BUILDING COMPLETION REPORT

With reference to your application dated 3-8-38
with a plan for the proposed buildings/additions and alterations on plot
No. 20/4 Survey Sheet No. T.M.3 Jamshed Quarter,
I have to request you to comply with the following requirements:—

AMENDED PLAN OF PLOT NO 20/4 J.MR. JAMSHED Q.

THE COSMOPOLITAN CO-OPERATIVE HOUSING SOCIETY.

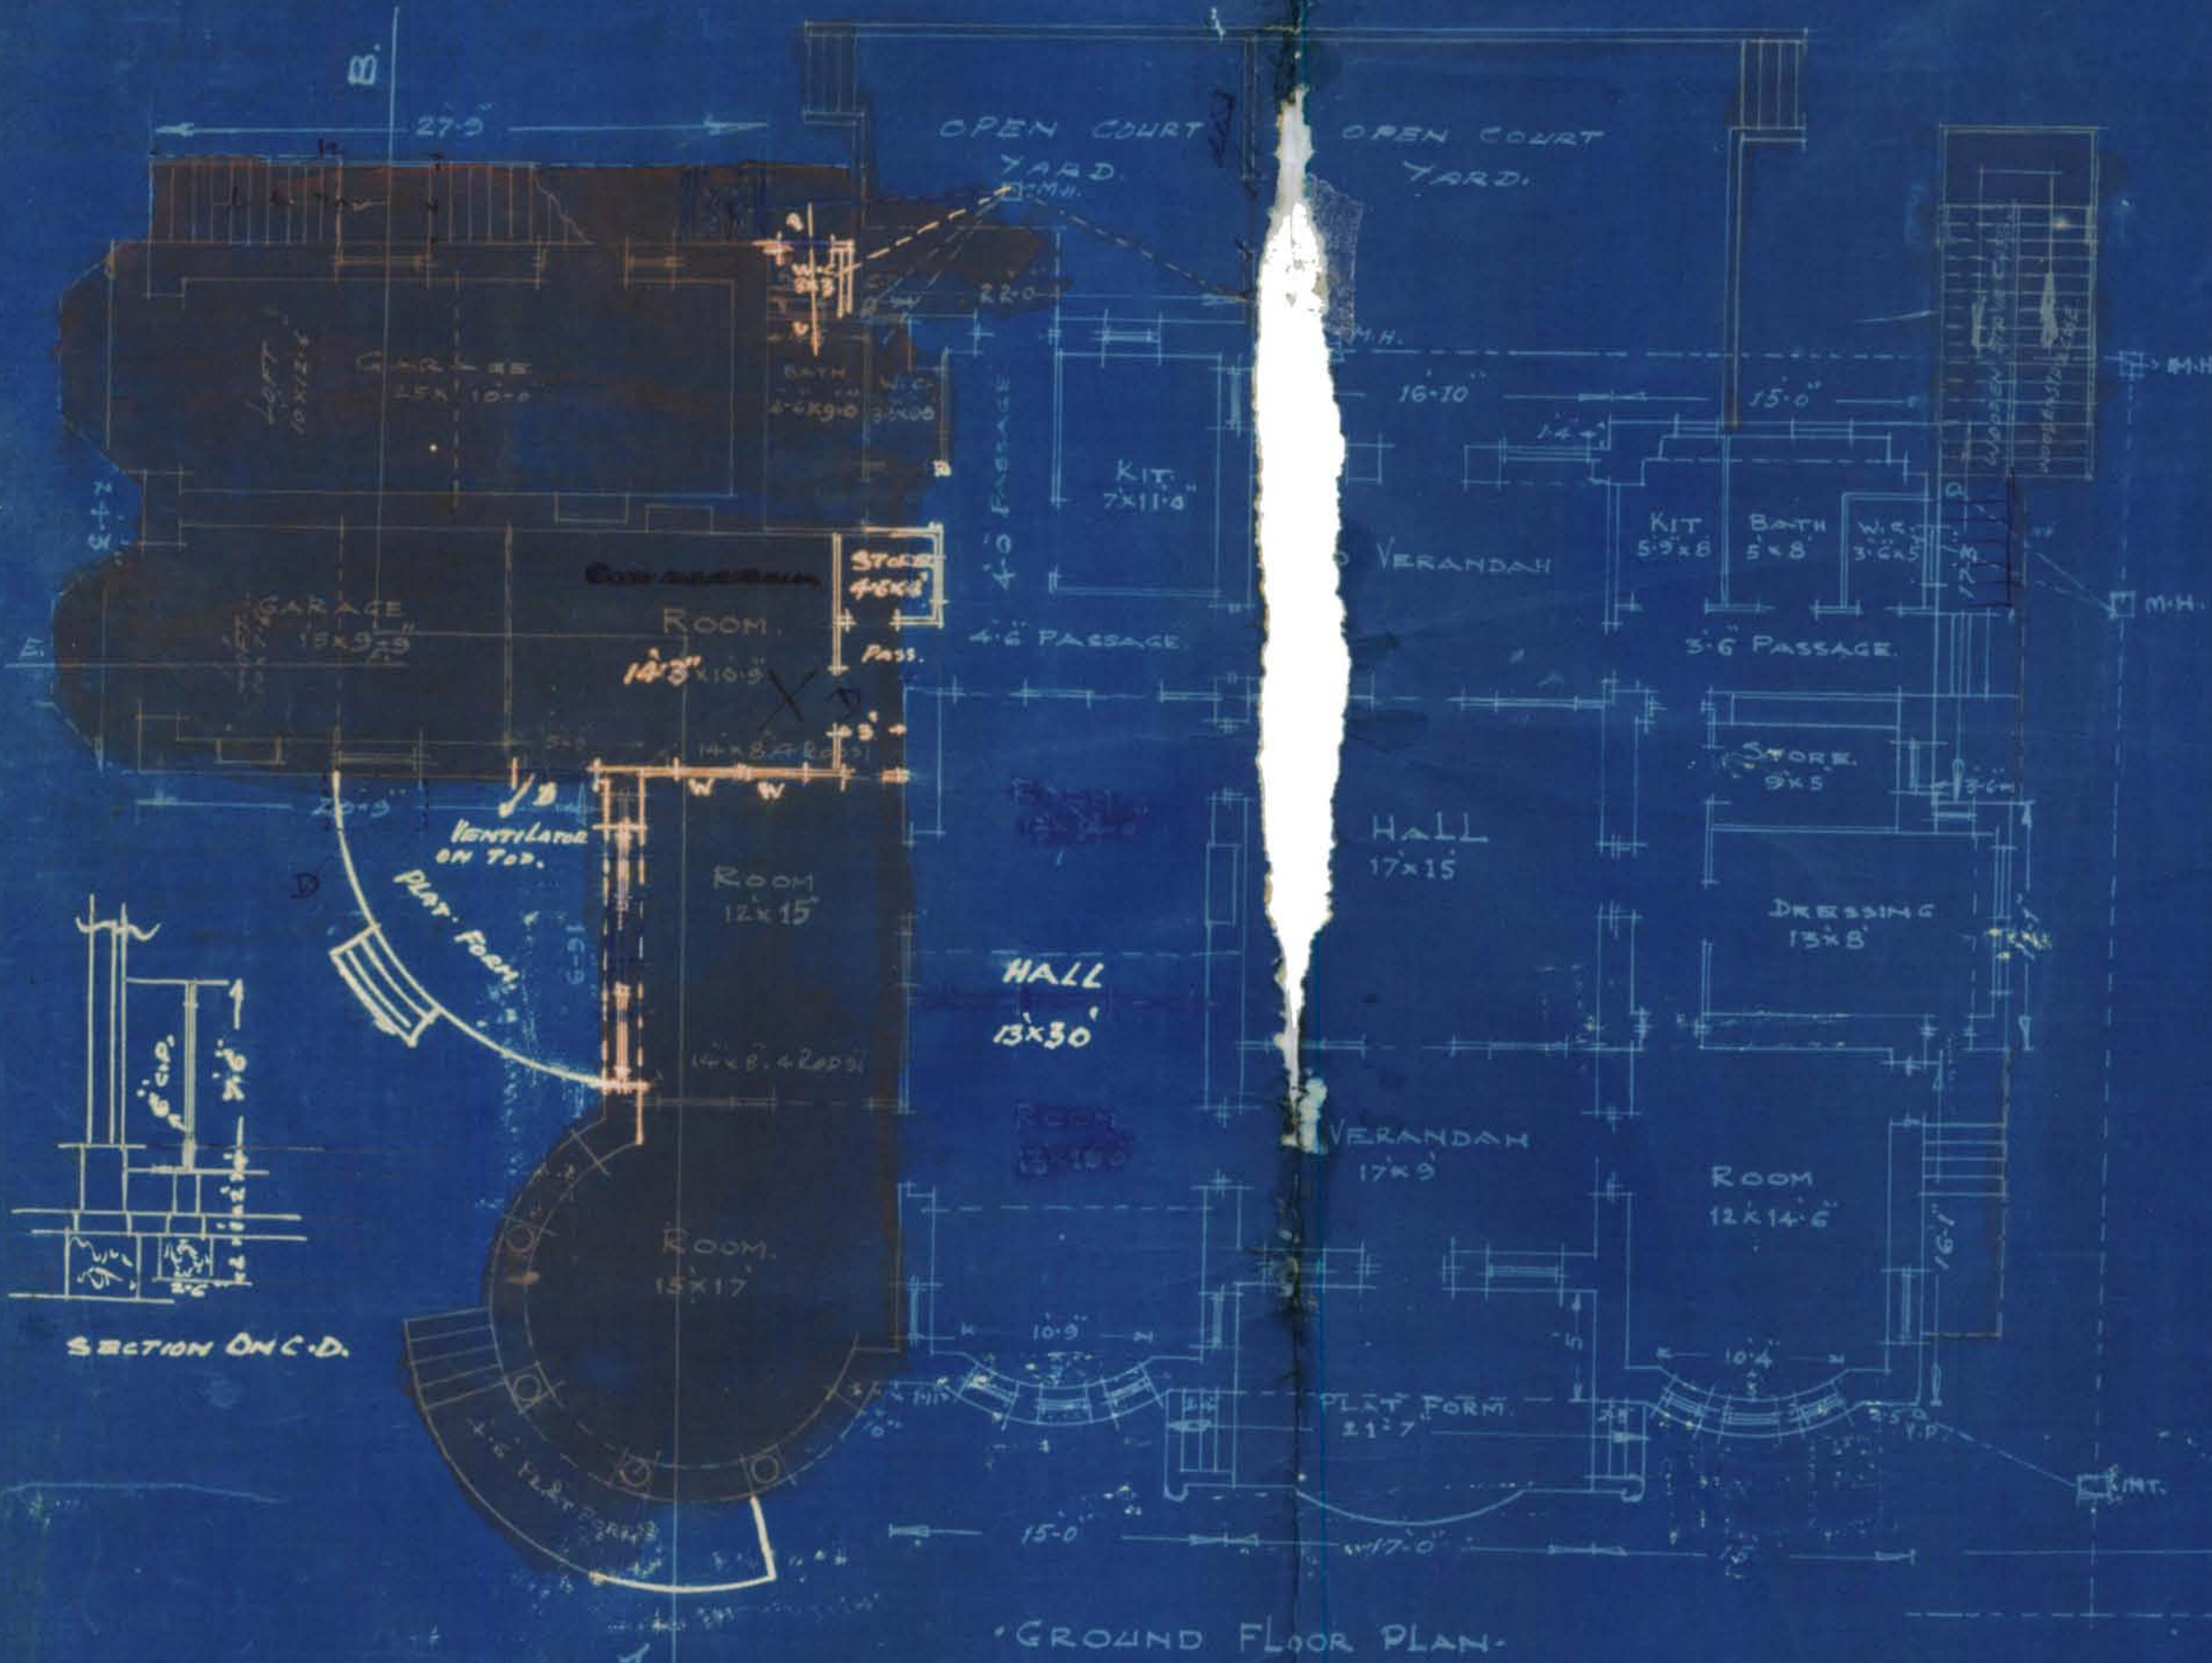
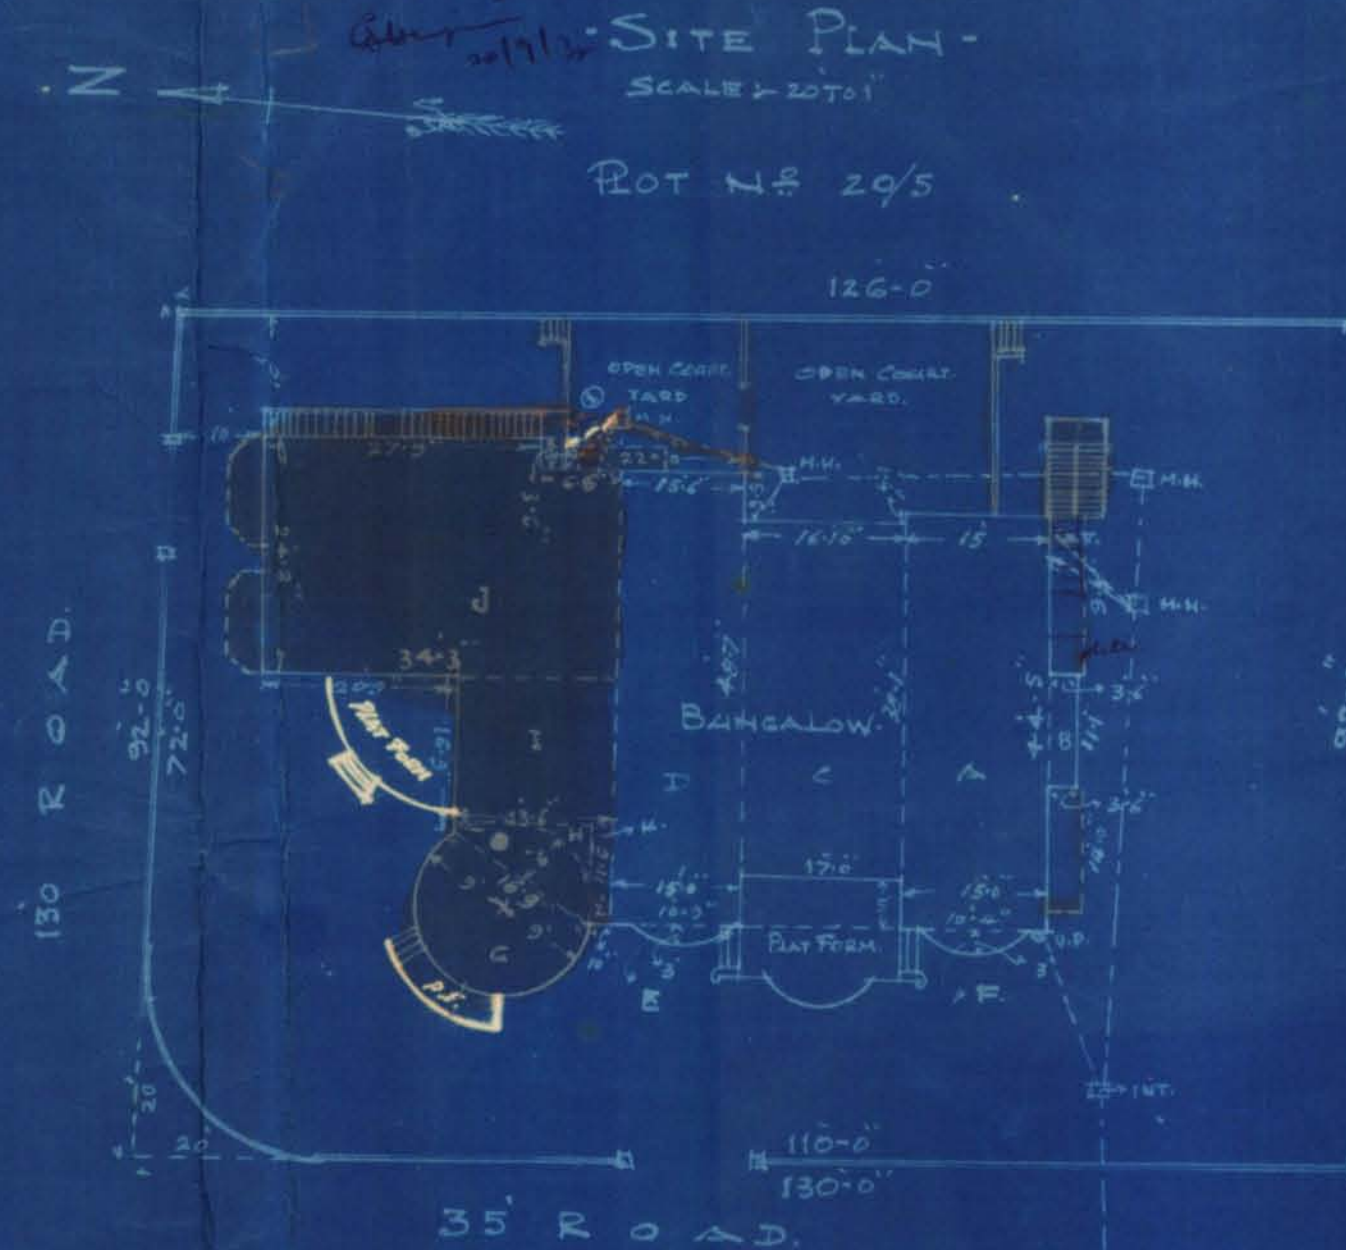
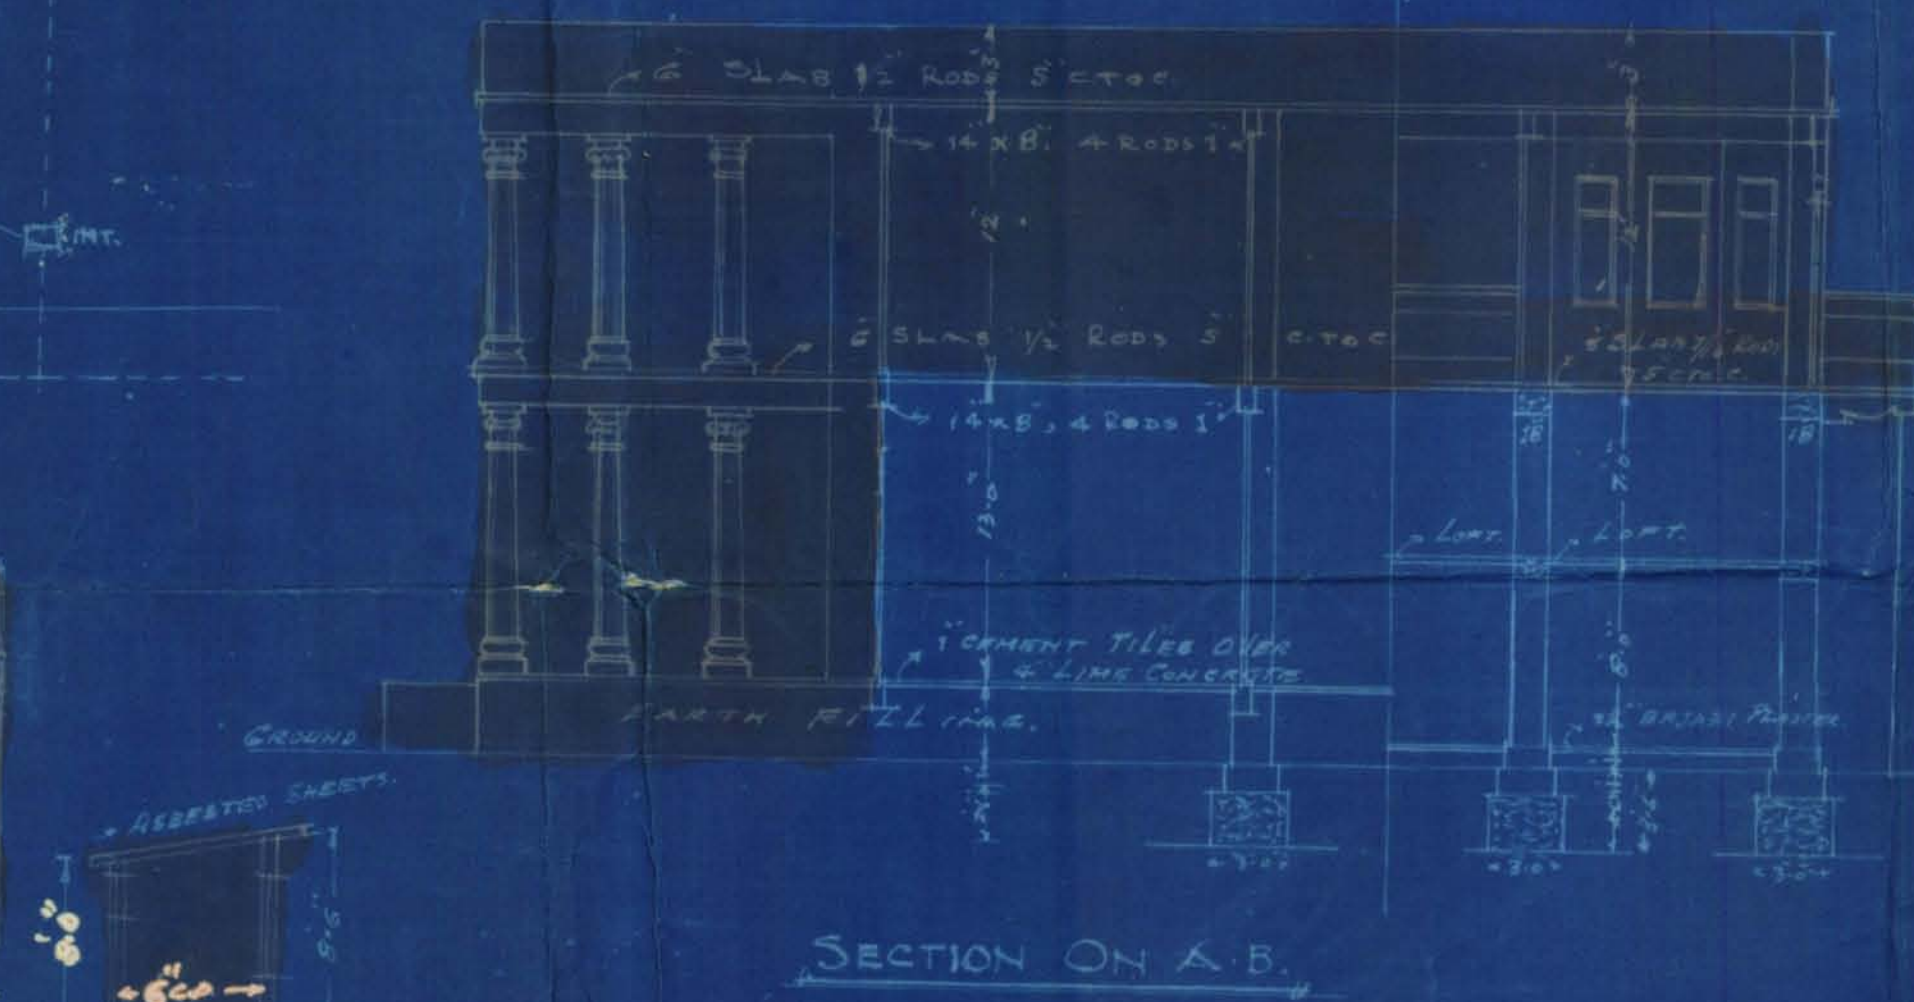
1. Objection No. 2. Stairs.

2. " " 5 & The Architect has not checked

3. Re Objection No. 6. The court yard cannot be

The compulsory open should not be
encroached upon.

4. The height of W.C. A. should be 8'-0"

The room is not properly ventilated. The
verandahs are covered roof. as the
rooms and the room in question will
have no access to air & light.

Unauthorized railings to the lofts should
be removed.

The owner has been prosecuted for deviations
from plans originally approved.

Distance from boundary to the staircase on the
south should be put down.

The plan is not in accordance with the structure
constructed on site.

Door to the loft & landing attached to the
same cannot be permitted.
